Building Code of Australia

Assessment Report

**Project Address: Telopea Stage 1A (Option B), Lot 5-7
Sturt Street, Telopea**

14 JULY 2021

Example of public corridor exceeding 40m.

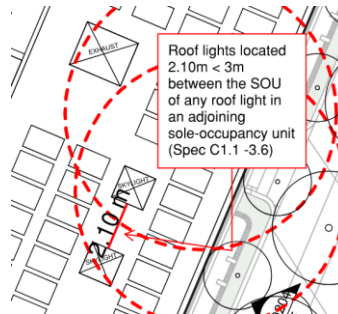
Tower E

- Upper ground floor Approx. 55m.

Basement 01

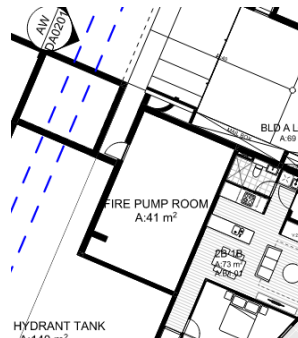
The proposed development is generally provided with two exits to all areas with the exception of the following areas which is proposed to be performance justified:

- Fire Pump Room (B01)

Tower E

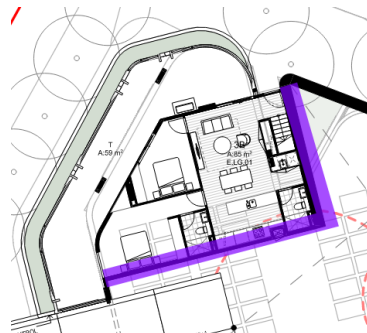
- Unit E.LG.01 (LG)

Basement 02

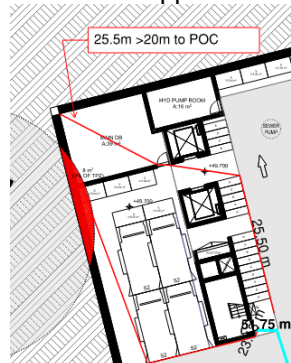
The following areas within the basement design have extended travel distances that exceed DtS limits and will be principally justified by Performance Justification.

- Main DB – Approx. 25.5m to POC

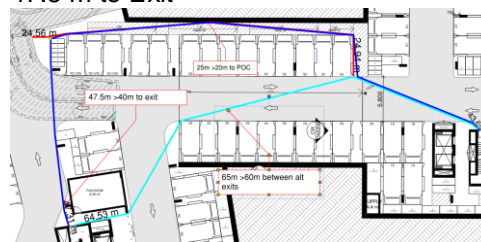
- Access ramp between the east & west carpark – Approx. 47.5m to Exit

- Storage cage - Approx. 26m to POC

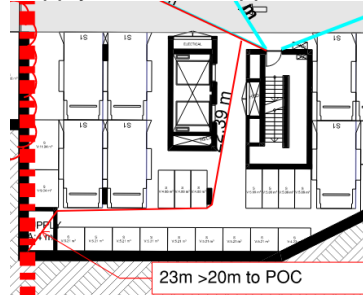
- Access ramp between the east & west carpark – Approx. 47.5 m to Exit

- Supply air room - Approx. 23m to POC

Tower A

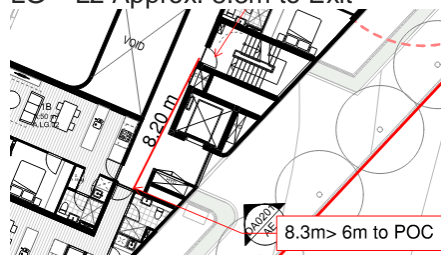
- B02 - Approx. 6.4m to POC
- LG – L2 Approx. 8.3m to Exit

Tower B

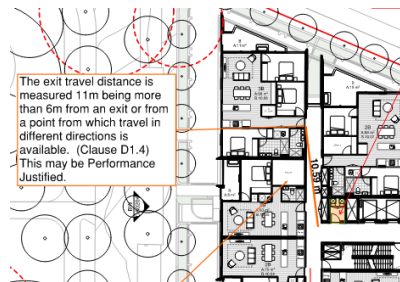
- LG Approx. 9.1m to POC
- UG Approx. 11.6m to POC
- L1- L2 Approx. 11.2m to POC
- L3- L13 Approx. 11m to POC

Tower C

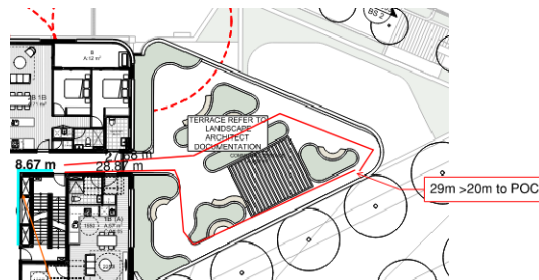
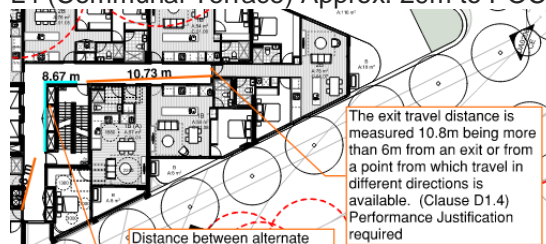
- L1- L3 Approx. 10.8m to POC
- L4 (Communal Terrace) Approx. 29m to POC

Tower D

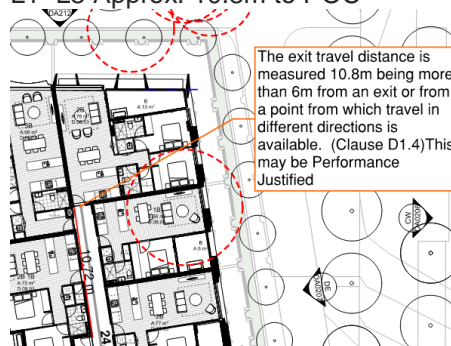
- LG Approx. 8.3m to POC
- UG Approx. 11m to POC
- L1- L8 Approx. 10.8m to POC

Tower E

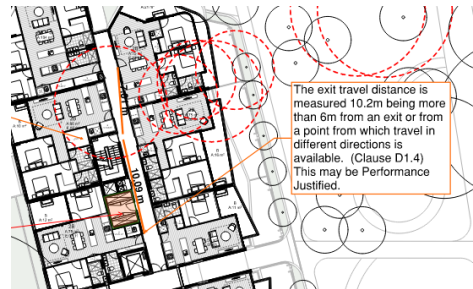
- L1- L7 Approx. 10.2m to POC

Basement 02

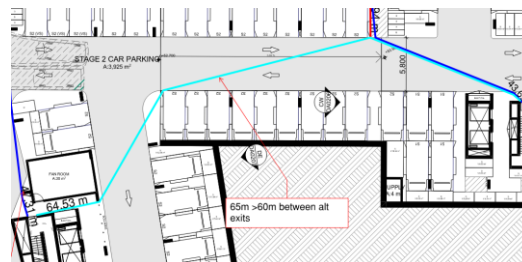
- Access ramp between the east & west carpark – Approx. 65 m between alternate exits

Basement 01

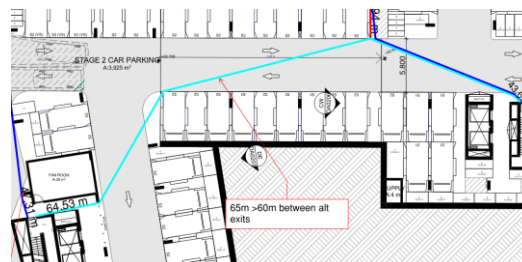
- Access ramp between the east & west carpark – Approx. 65 m between alternate exits

Lower Ground

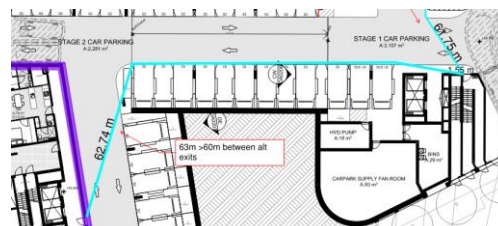
- Access ramp between the east & west carpark – Approx. 63 m between alternate exits

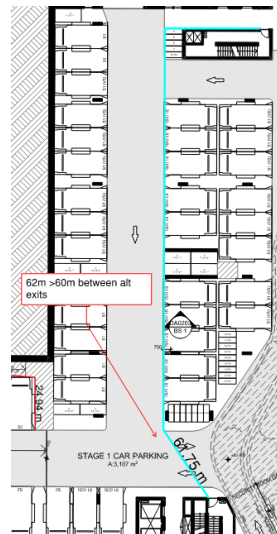
- Fire stairs between the North & South of the carpark – Approx. 62 m between alternate exits

Tower C

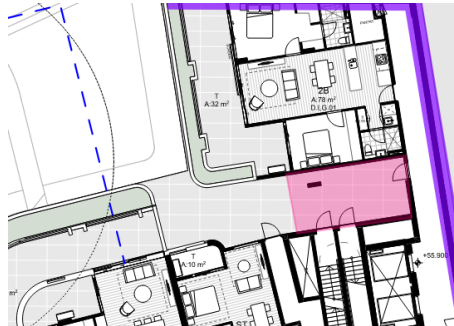
- The fire isolated exits serving tower C – Approx. 8.7m in lieu of 9m.

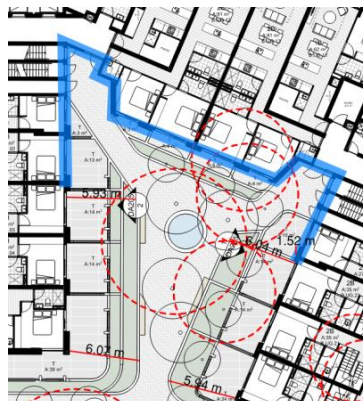
Where a path of travel from the point of discharge of a fire-isolated exit necessitates passing within 6 m of any part of an external wall of the same building, measured horizontally at right angles to the path of travel, that part of the wall must have an FRL of not less than 60/60/60 and any openings protected internally in accordance with C3.4, for a distance of 3 m above or below, as appropriate, the level of the path of travel, or for the height of the wall, whichever is the lesser.

The discharge of the following exits requires occupants to pass part of the external wall which must have an FRL of not less than 60/60/60 and any openings protected internally in accordance with C3.4.

Tower B

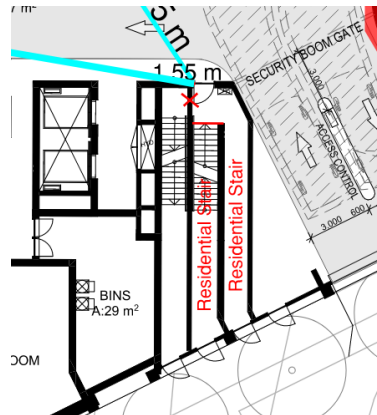
- The two residential stairs (western) are located adjacent to each other (UG).

- The two residential stairs (eastern) are located adjacent to each other (UG).

E1.3
 Fire hydrants

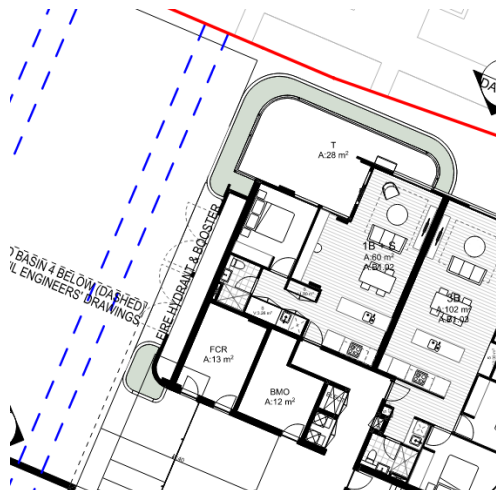
The fire hydrant booster is located adjacent the entry to Tower A and is not located within sight of the main entrance into the building and not facing the street, noting that there are multiple pedestrian entries. A Performance Solution is required to justify this technical non-compliance.

E1.8
 Fire control centres

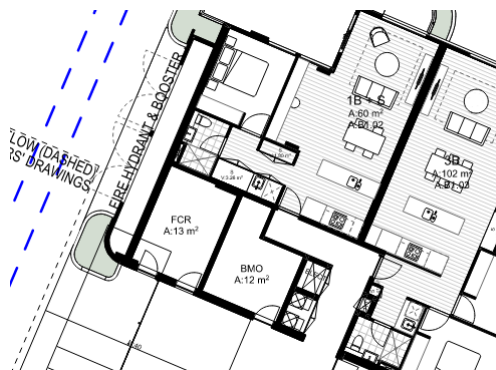
The effective height of the united building is over 50m. A fire control room is required in accordance with Specification E1.8.

There is a technical non-compliance as the fire control room is in Tower A and is not located from the front entrance of the building given there are multiple entries. Performance justification will need to address this.
